1. Does this device meet the requirements for operation in the 5400 – 5725 MHz band specified in KDB 443999? Yes, Section 3.2 of the user manual lists the available channels and states, "This device will not operate in 5600 MHz - 5650 MHz band". Furthermore, this is a client device with no radar detection and no ad-hoc capability. It meets the 15.202 definition of a client device.

Band edge Compliance for 5580 MHz

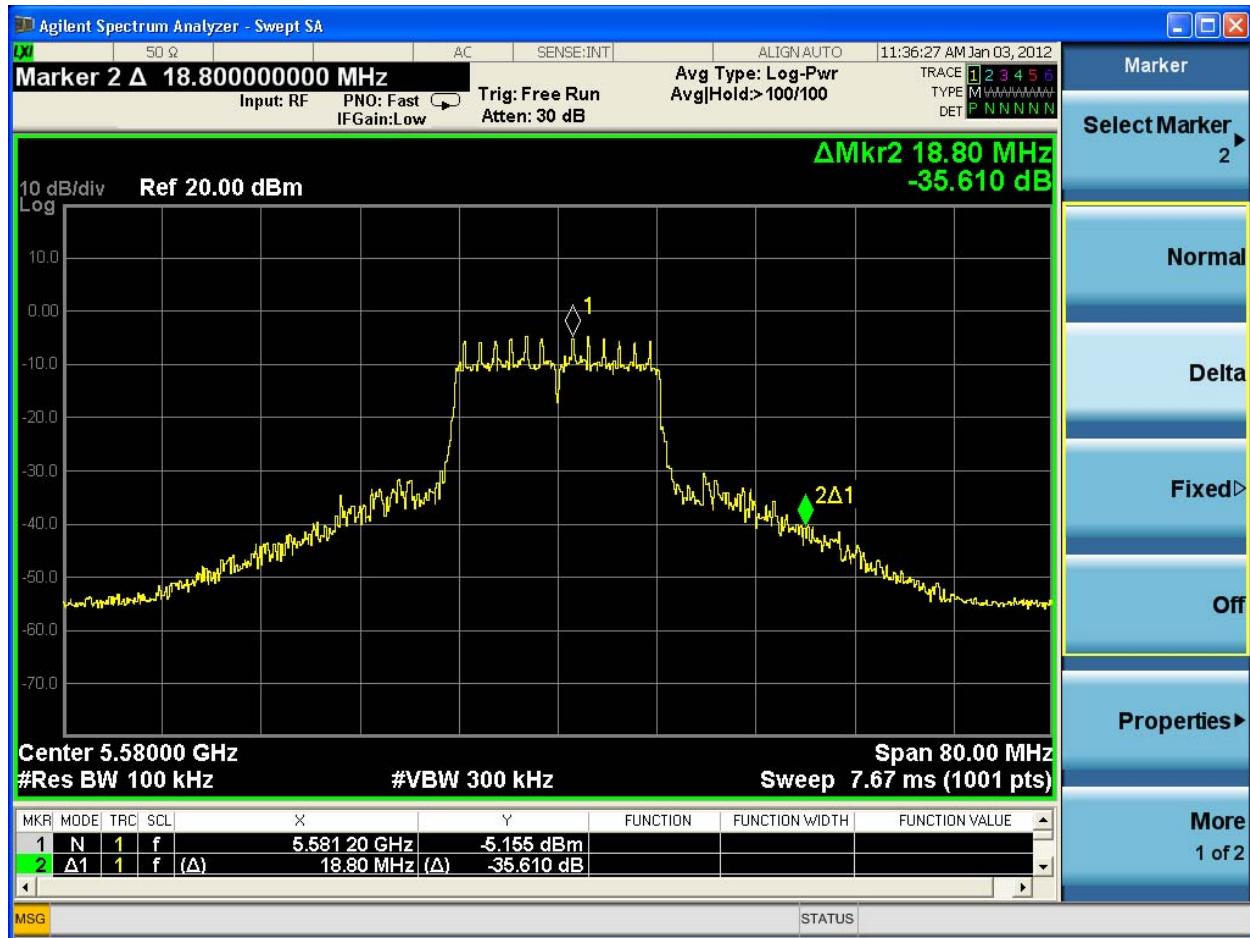
3. Verify that the 5600 – 5650 MHz band is notched. The test report should include 20 dB BW plots for the 5600 and 5650 MHz band edges and an attestation statement that the device does not transmit in the notched band. [See measurements below](#)

Value	Limit	Result
-35.6dBc	≤ -20 dBc	Pass
